Question & Answer Matrix
April 7, 2026 - City Council Meeting

THE QUEST

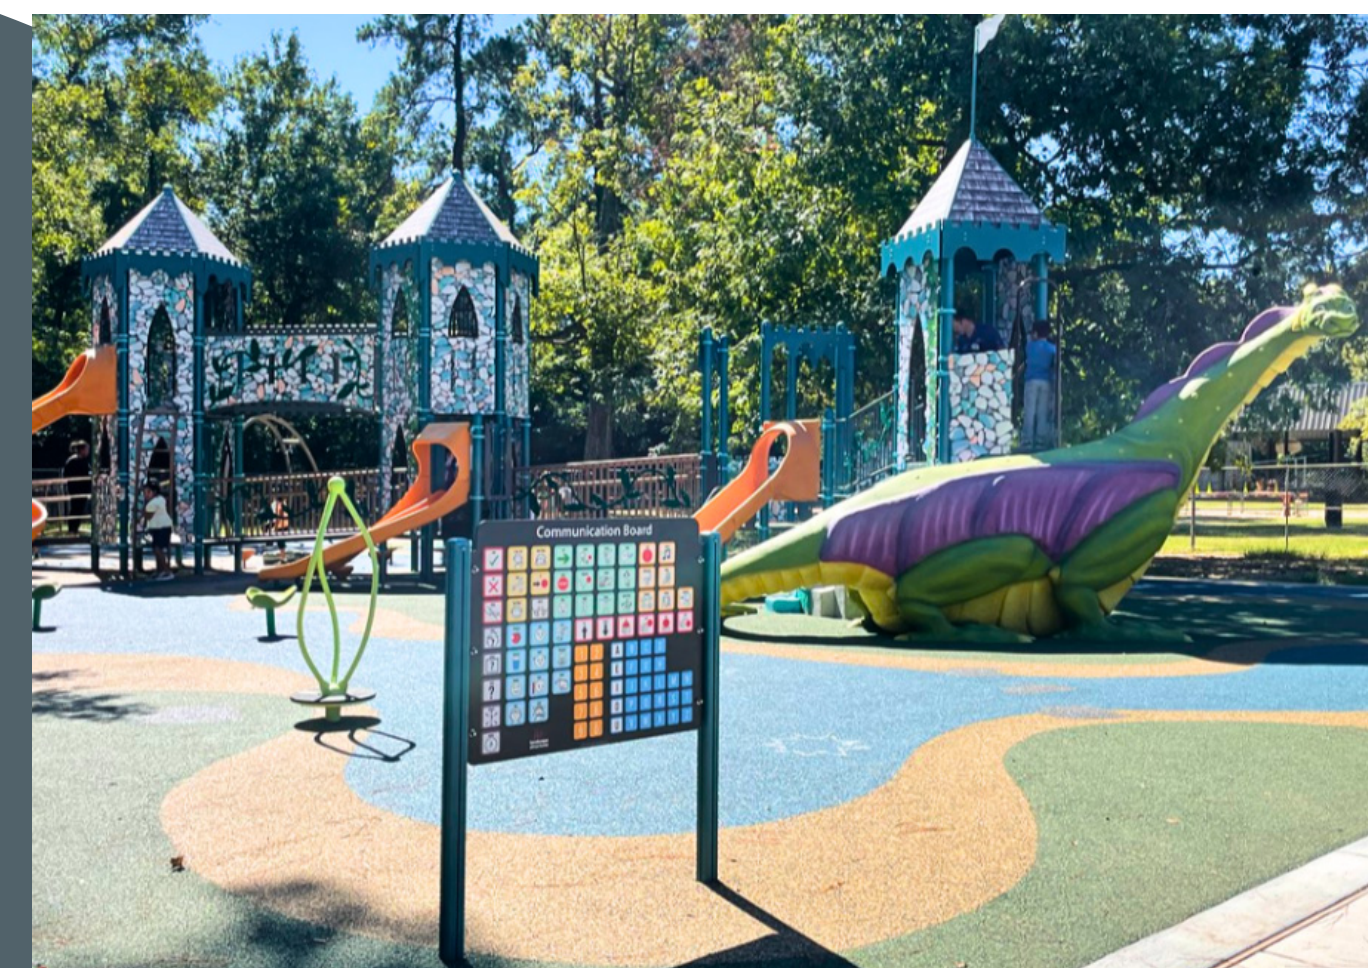
33	6902	Weinberg	<p>On page 142 of the agenda packet, questions 2 and 3 reference 6 options labeled “Option A” thru “Option F” for The Quest and Woodsy Wonders. I don’t see where those 6 options are defined. Would you please describe (or show, if they’re pictures) what those 6 options were?</p>	<p>These character images provided for the play equipment look and feel voting exercise during Phase II have been attached Exhibit A on page 23 of this matrix.</p>
34	6902	Weinberg	<p>I’m noticing on page 147 of the agenda packet that the survey showed respondents preferred less-enclosed space over more-enclosed space – but the tree snag tower in the proposed site plan and its adjoining tree house access structure appear to be more-enclosed spaces. Is there a reason we choose to go with more-enclosed spaces?</p>	<p>See response to question 29 in the matrix.</p>
